Access Compliance Report

Public Rights-of-Way

Intersection ID: 51356	Main Street: BRENTMOOR_DR	Cross Street: PEARL_ST	Location: NW
ADA ID: 0A30723EFF77	Ramp Type: BlendTrans1	Initial Pass/Fail: Fail	Overall Compliance: No
Severity Score: 12.5			
Codes/Mitigation Info/Possible Solution		Field Measurements/Component Compliance

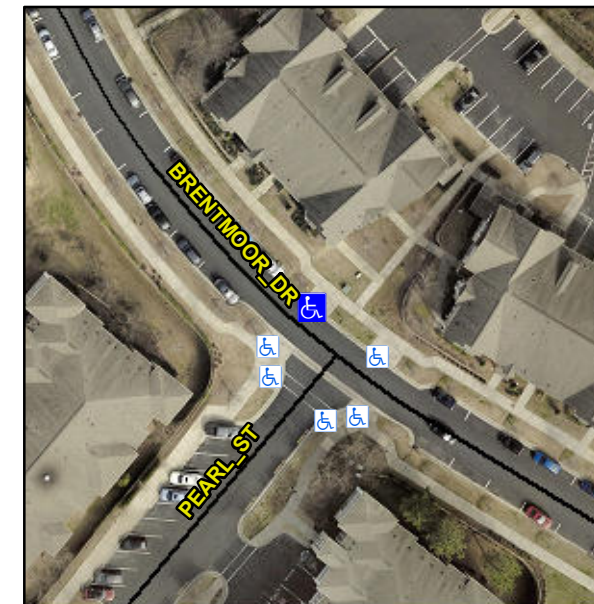
Not Found, R304.5.3

Compliance	Description	Data	Compliance	Description	Data
N/A	Ramp Length (in)	96.0	Yes	BlendTrans Slope (%)	4.4
Yes	Ramp Width (in)	48.0	No	BlendTrans XSlope (%)	5.3
N/A	Flare Type LT	N/A	N/A	Flare Type RT	N/A
N/A	Flare Slope LT (%)	N/A	N/A	Flare Slope RT (%)	N/A
N/A	Flare Traversable LT?	N/A	N/A	Flare Traversable RT?	N/A
N/A	Landing Length (in)	N/A	N/A	DWS Provided?	N/A
N/A	Landing Width (in)	N/A	N/A	DWS Contrast?	N/A
N/A	Landing Slope (%)	N/A	N/A	DWS Length (in)	N/A
N/A	Landing X Slope (%)	N/A	N/A	DWS Full Width?	N/A
N/A	Landing Curb? (Y/N)	N/A	N/A	DWS Offset (in)	N/A
N/A	Shared Landing?	N/A			
N/A	Gutter Ponding?	N/A	N/A	Gutter Slope (%)	N/A
N/A	Gutter Lip Ht (in)	N/A	N/A	Gutter X Slope (%)	N/A
N/A	Painted X Walk1?	No	N/A	Painted X Walk2?	N/A
	X Walk 1 Direction	To SW		X Walk 2 Direction	N/A
	X Walk 1 Width (in)	N/A		X Walk 2 Width (in)	N/A
	X Walk 1 Slope (%)	1.8		X Walk 2 Slope (%)	N/A
	X Walk 1 X Slope (%)	5.5		X Walk 2 X Slope (%)	N/A

N/A	Ramp inside XWalk1?	N/A	N/A	Ramp inside XWalk2?	N/A
	Road Slope (%)	5.5		Clear Space?	N/A
	Road X Slope (%)	1.8	N/A	Clear Space to XWalk (in)	N/A
N/A	Any Obstructions?	N/A	N/A	Storm Grate/Utility Hazard?	N/A
	Obstruction Type			Storm Grate/Utility Type	
		N/A			N/A
			Yes	Surface Condition? (G/P)	Good
			No	Curb Slope (%)	25.3

Remove & Replace Curb Ramp With Two New Directional Ramps or Equivalent.
